NIWA APARTMENTS

513 FIRST AVENUE NORTH
DESIGN REVIEW RECOMMENDATION
11.14.18 | MUP # 3029562-LU

Figure 1. Massing modulation at east facade.

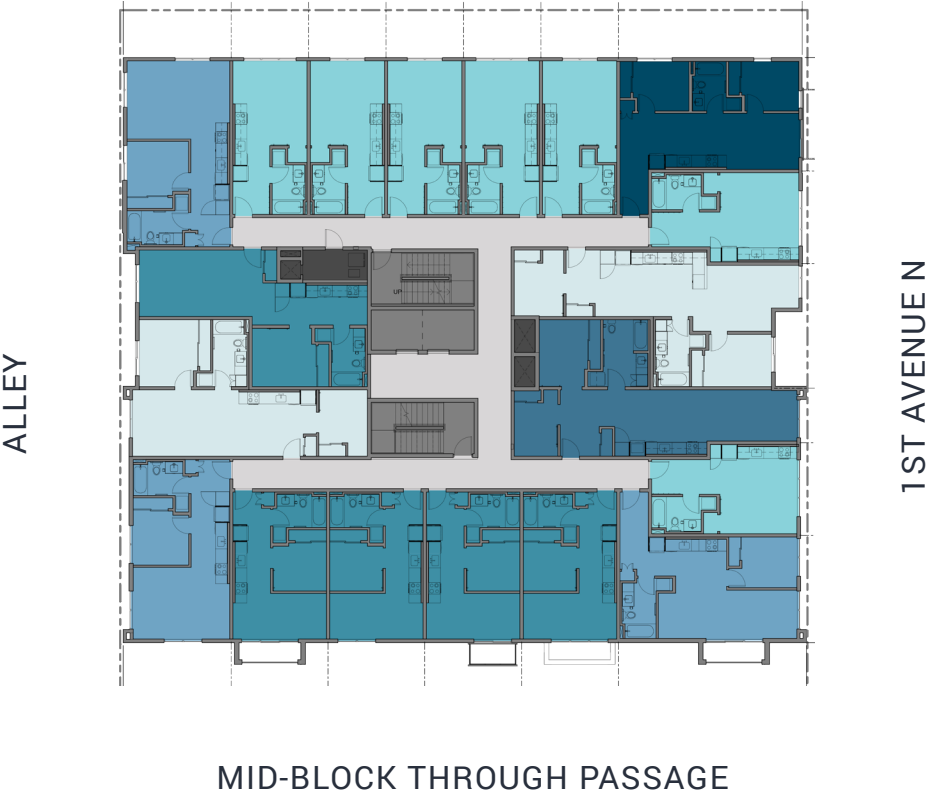
A) Break up the 1st Ave N façade into two distinct masses, with different material treatments and height if needed. Detailing of the materials is key. The Board indicated support for departures to allow the street facades to extend beyond 45’ in height (up to 65’ height for one massing and up to 75’ for the other massing section), if needed to achieve this guidance. See departures below.] (DC2-B-1, DC2-III-I)

E) Consider having more residential units face 1st Ave N and providing active spaces that will provide “eyes on the street” and activate the facade (PL2-B-1)

The massing has been further articulated with the use of materials and window fenestration (See Figure 1). This project still seeks a departure for the height / setback required in order to provide better differentiation between the white and yellow masses.

The typical floor plan has been reworked so that there are units facing both the mid block passage, 1st Ave N and the alley (See Figure 2).

Figure 1. Mid-block passageway from the alley.

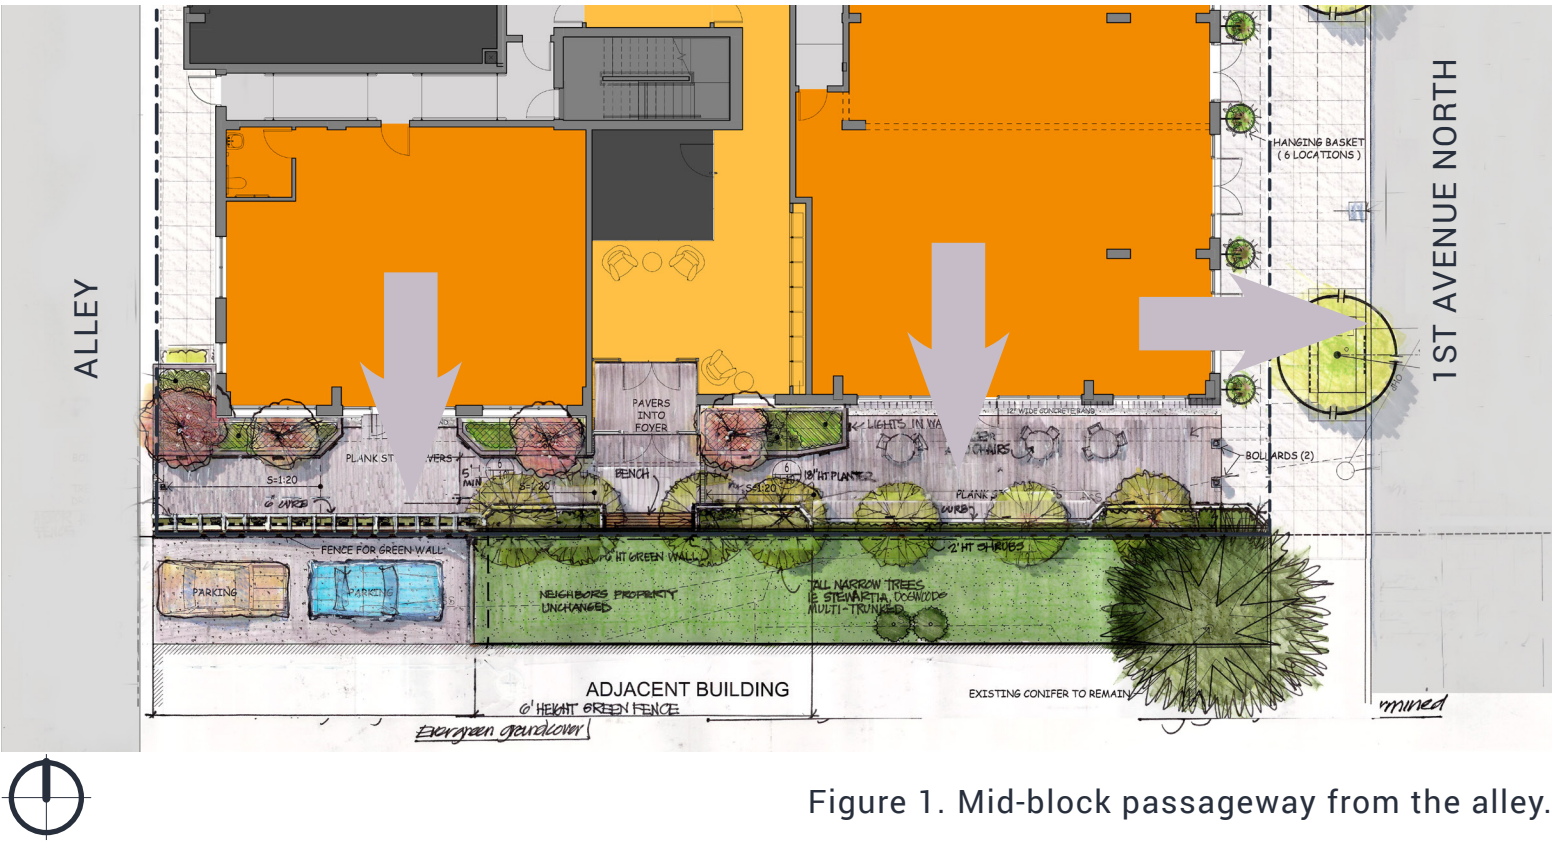
A) Locate the residential entry along this passageway as shown, to help ensure activation of the passageway (PL3-A-2)

B) Have the two site owners agree to and record an easement agreement with King county to ensure the passageway design (PL1-B-1)

C)Provide an alternative passageway design if the easement can't be secured. (PL1-B)

The ground floor plan has provided the residential entry off of the half block through passage (See Figure 1). The design and articulation of this entry has been developed to provide a vibrant focal point drawing pedestrians from 1st Ave and the alley. The use of color, glass, and light all serve to provide further way-finding and activate the spaces around the residential entry (See Figure 2,3).

An agreement is being discussed between the property owners and the applicant and conversations continue. The current design has incorporated those discussions and the proposed plan has been developed to not require an easement while still providing access, privacy and activity to create an attractive pedestrian environment (See Figure 1).

The proposed plan has been developed to not require an easement while still providing access, privacy and activity to create an attractive pedestrian environment (See Figure 1).

Figure 1. Additional trees on site provide a buffer for the adjacent property as well as creating an inviting environment.

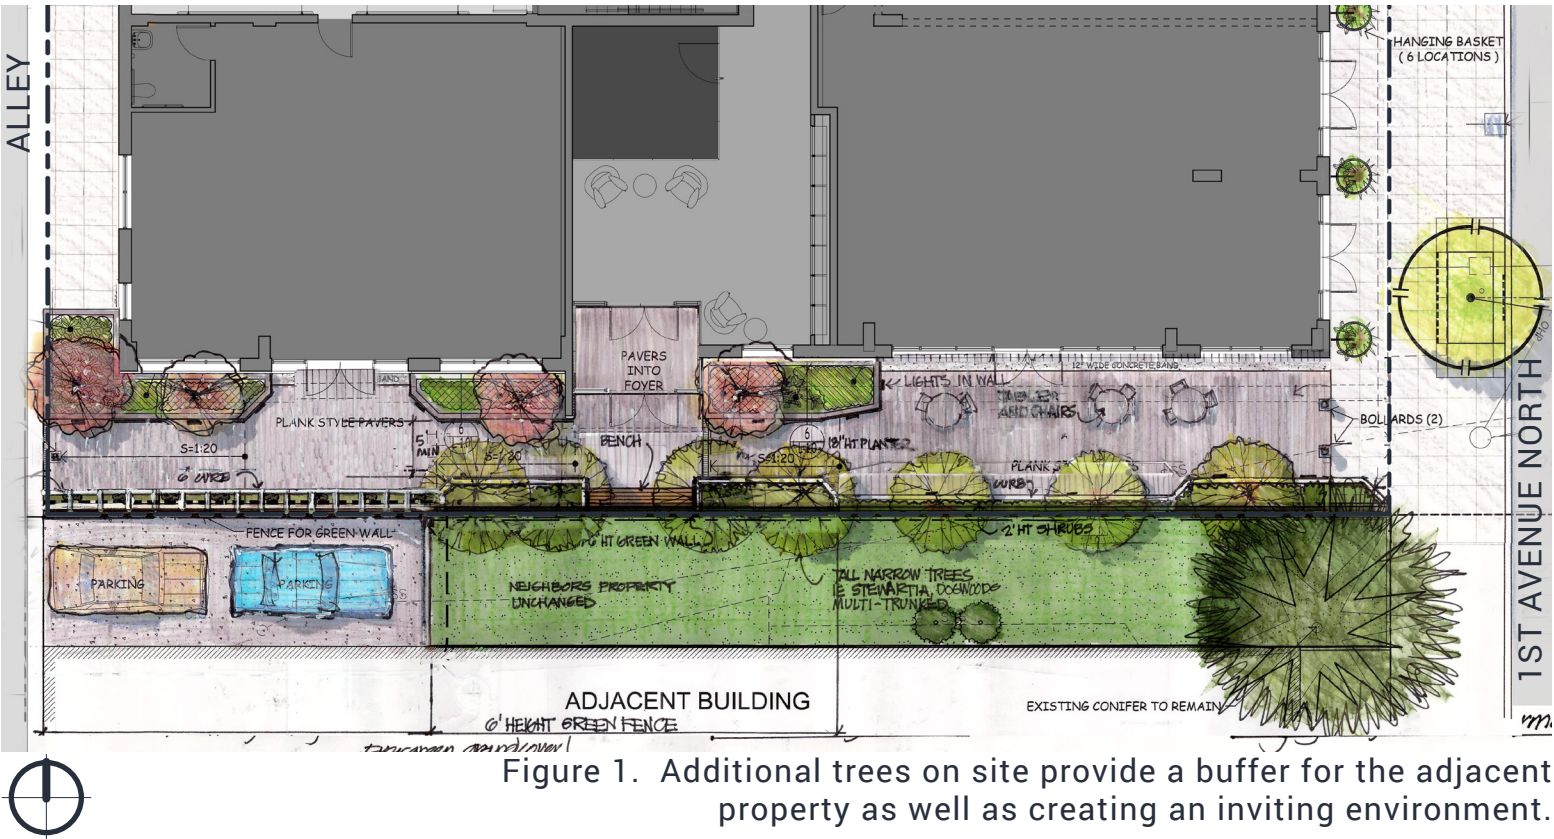
A) Show how the entry and half block passage way will be experienced, addressing safety, privacy, signage, lighting and the entry sequence, and the corner retail space. (PL1-B, DC4-B, DC4-C)

C) Design the retail space entries to read as commercial entries, not residential. (PL3-A-1)

Additional images of the entry and half block passageway have been provided. Safety has been addressed by providing bollards at the entrances to the passage as well as a high degree of transparency.

The retail entries are treated differently from the residential entry. The residential entry located in the center of the block utilizes a large glass mass with a vertical wood accent. The use of glass, the massing of the building above and the wood accent wall highlight the residential entry, while the commercial entries feature a more consistent storefront and awning combination.

Figure 1. Window overlay at south facade.

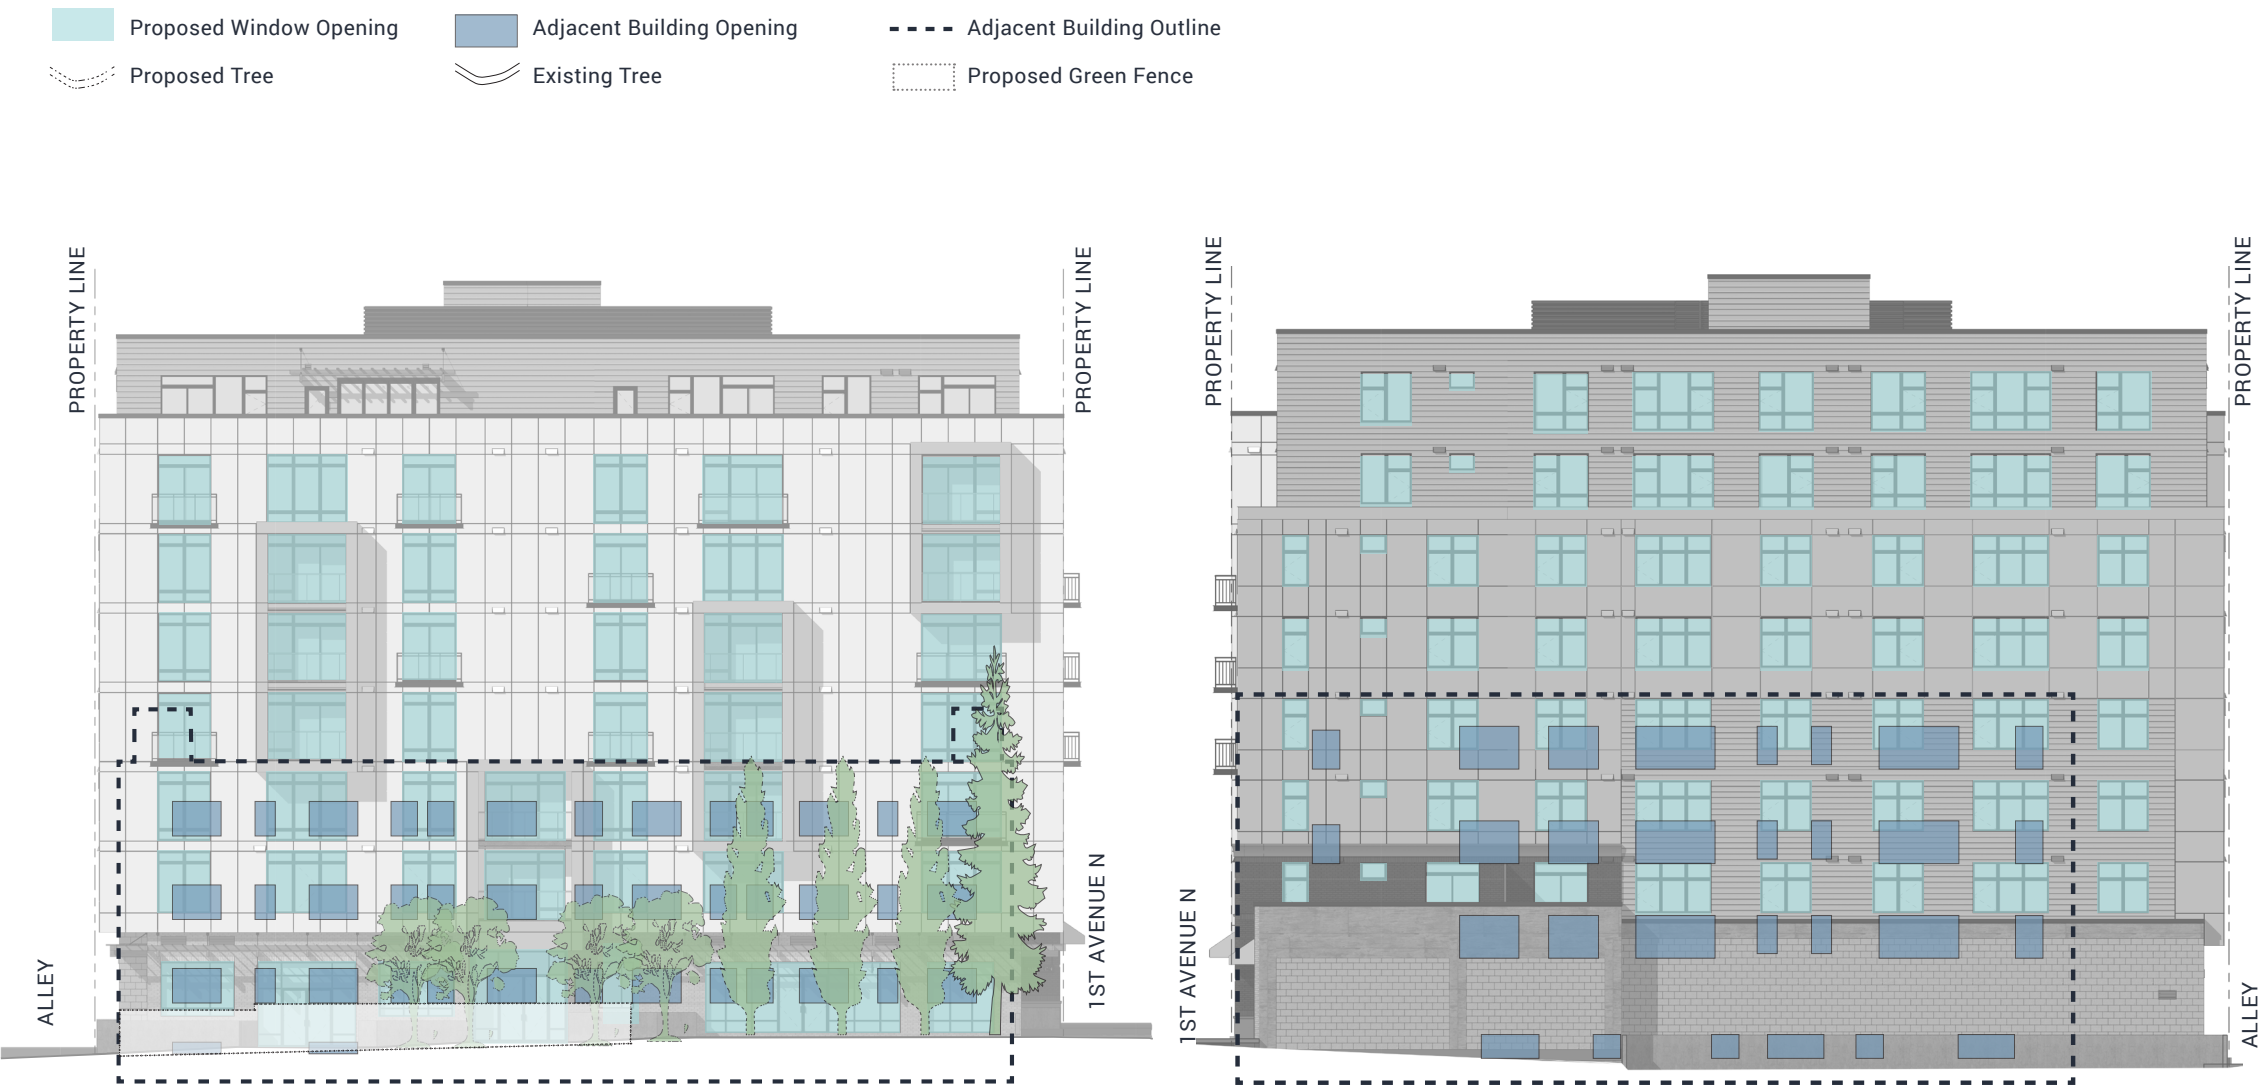
A) Provide window studies to show the relationship of the design to the existing structures at the north and south lot lines

B) If needed, provide sections showing the relationship of any upper massing protruding over the street level spaces.

Window studies of the adjacent buildings to the north and south have been provided and are overlaid with the proposed building elevation on page 17 of this package. Additionally diagrams have been provided on page 18 of this document to show the relationship of the window patterning and fenestration with neighborhood precedents.

A section through the mid-block through passage indicating the character at the street level. Proposed vegetation and outdoor seating creates an inviting environment.

Proposed Massing

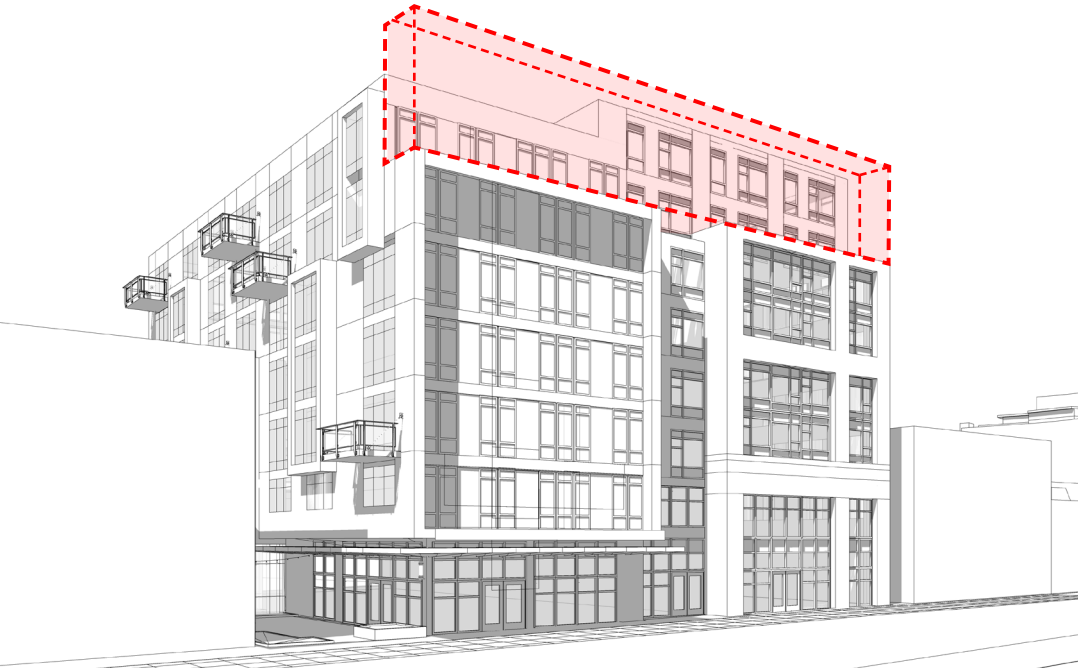
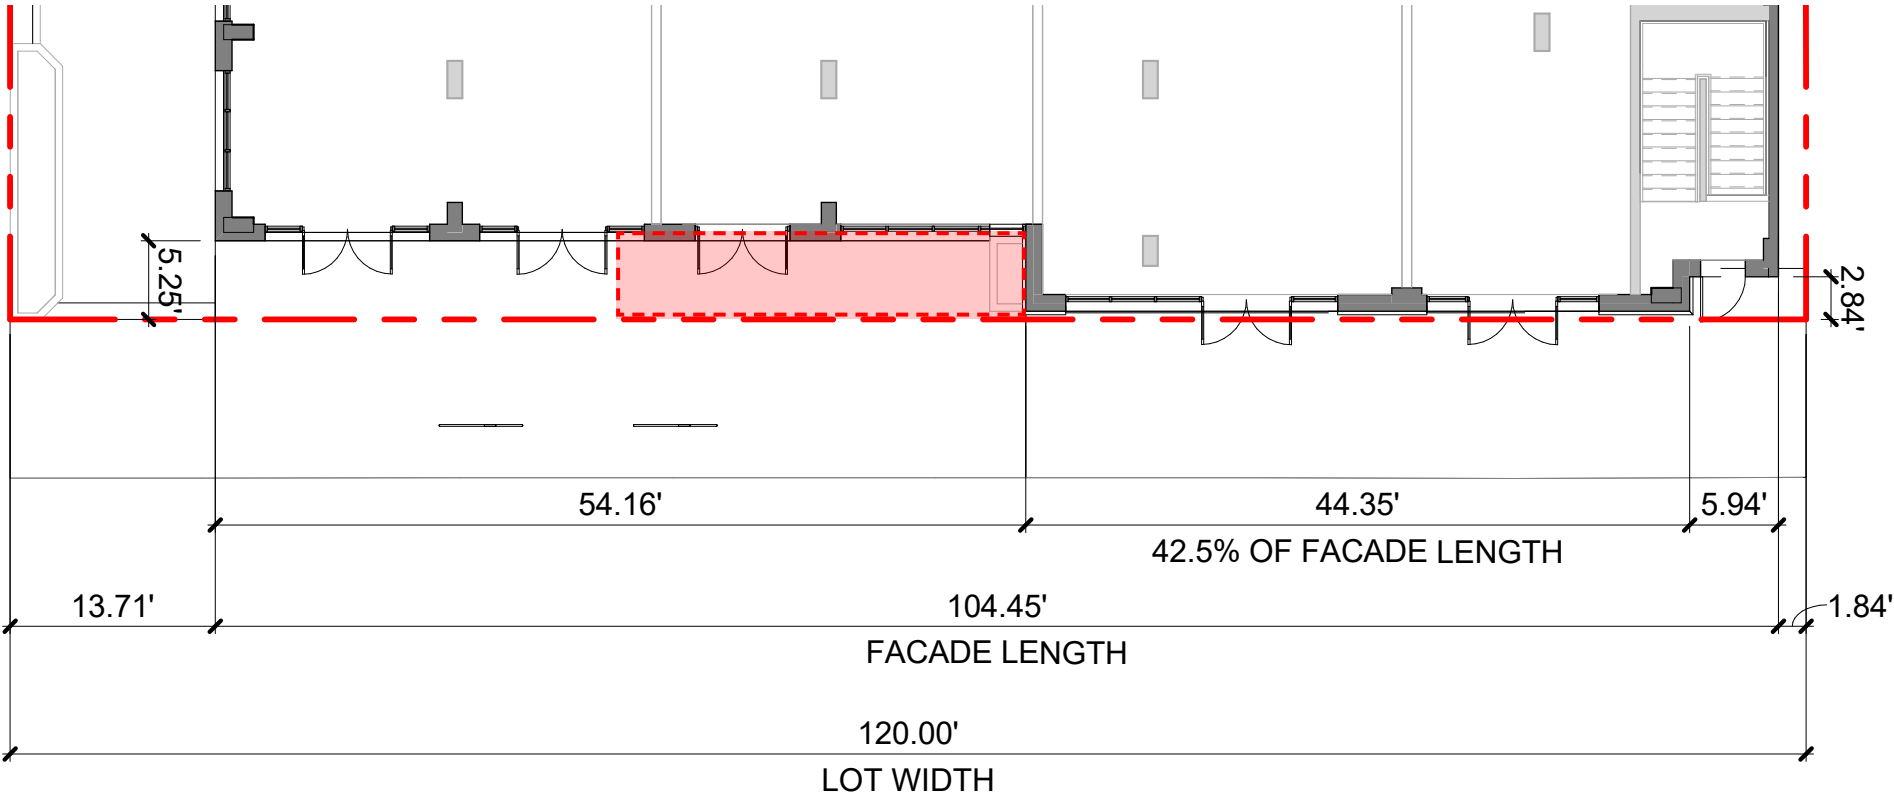
Request the required 10 foot setback above 65 feet on the 1st Avenue North facade be vacated.

This departure allows for the two distinct masses to step back at different elevations, which will help break down the large mass of the building along 1st Avenue North (CS2-IV-ii). The north mass is set back 5.86 feet above 64 feet, while the south mass continues up at the property line to an elevation of 74 feet to create more visual interest and clearly communicate that the two masses are distinct (CS2-IV-ii).

Proposed 1st Ave N (East) Street Elevation

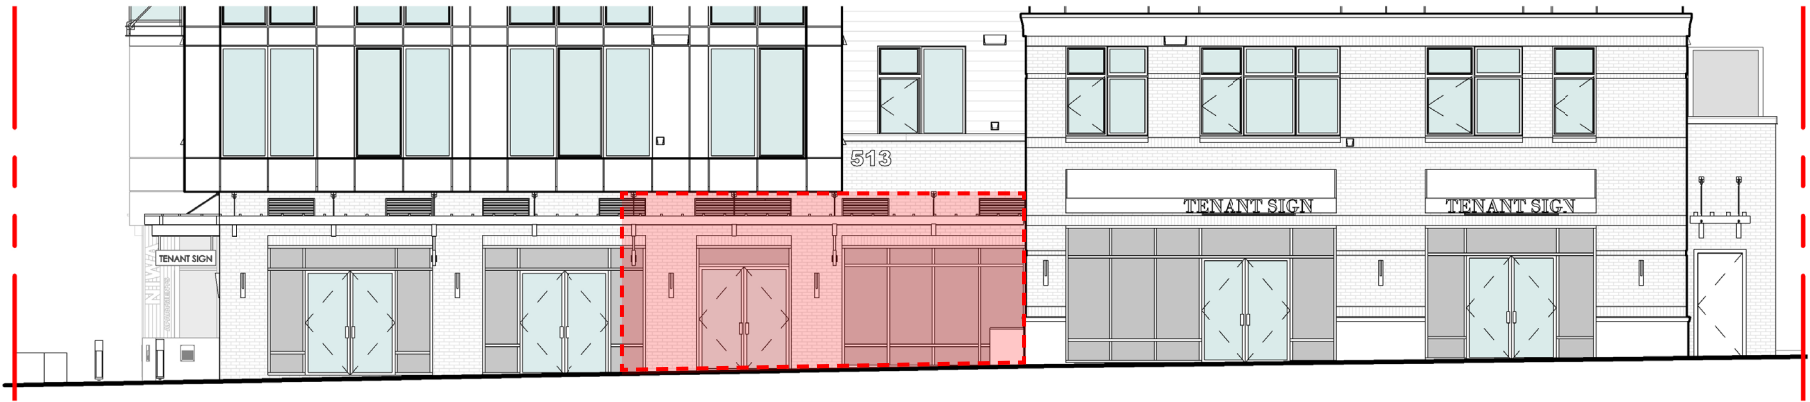
Request the 70% facade length on street line requirement be reduced on the 1st Avenue N (east) facade to allow for 42% of facade length.

This Departure allows for a more pleasing composition of the facade, providing variation in depth of massing of the building (CS2-IV-ii), creating a wider sidewalk space for a more engaged, friendly pedestrian experience (CS2-II-iii) as well as opening up and helping to create relief drawing attention to the mid-block through passage and pedestrian activity in this space.

Proposed Site Plan

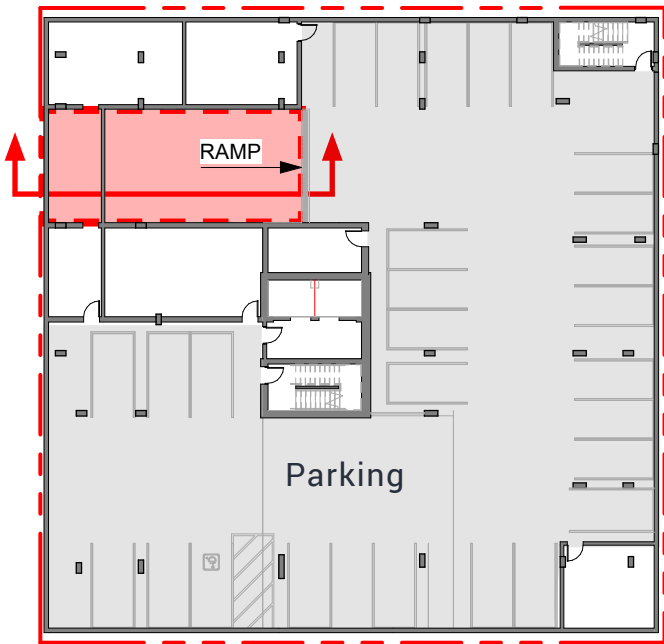
Request allowance for the primary pedestrian entrance be located on south facade, on mid-block through passage. Retail entrances to be from Class I street (1st Avenue North) and from mid-block through passage, less than 3 feet below sidewalk grade.

This departure allows for more active and engaging retail spaces and more retail frontage along the Class I pedestrian street. (PL3-I, PL3-I-ii) it also provides a more appropriate human scaled entrance for the residences and activates the mid-block through passage between the street and alley (DC1-VI-ii, DC2-III-ii).
